TSRG Meeting Feb. 11, 2020

Discussion of revision to
DG Tariff Screens

Expedited Process

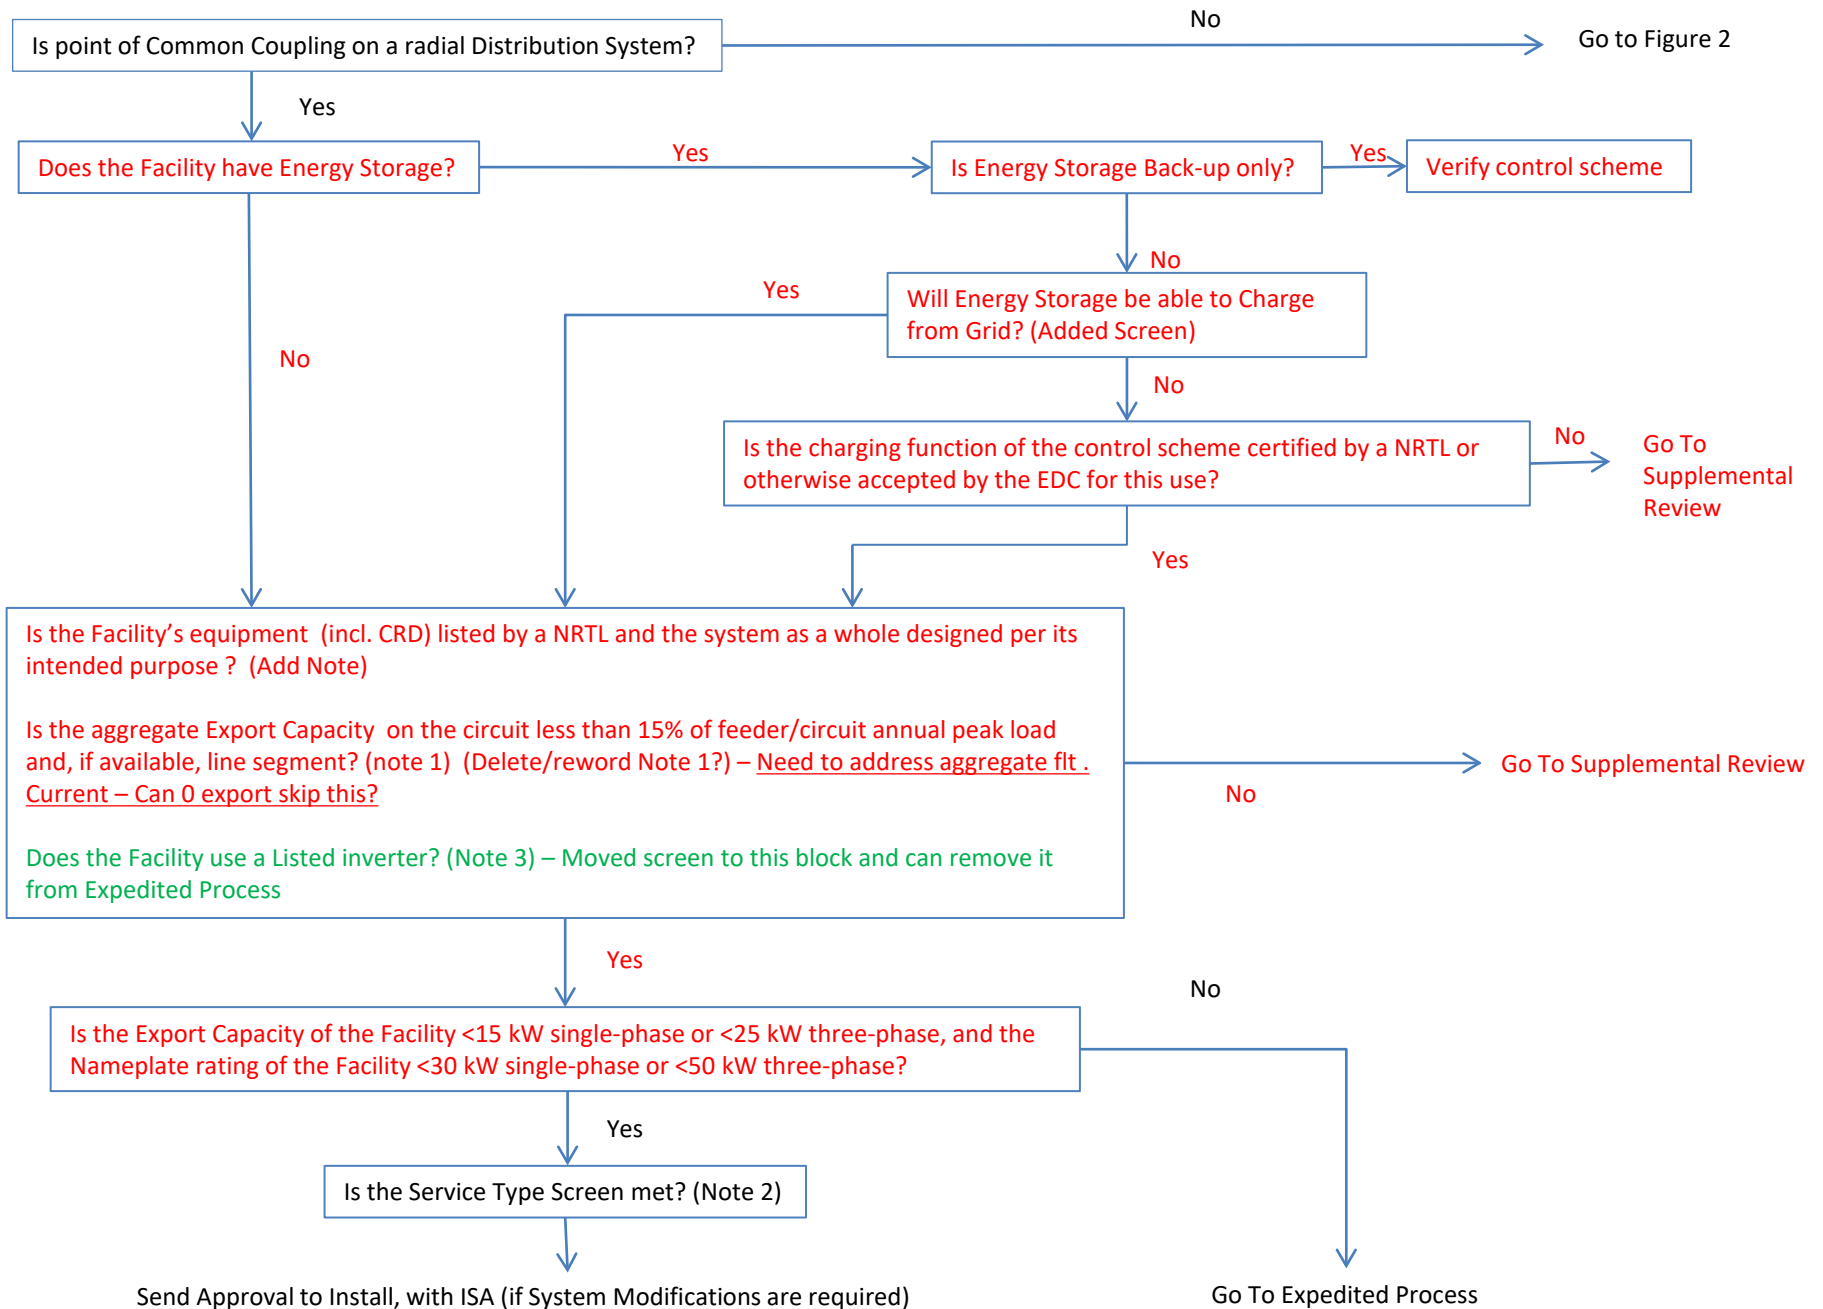
Is the Facility Listed per (Note 3)?
(This screen is redundant and can be removed)
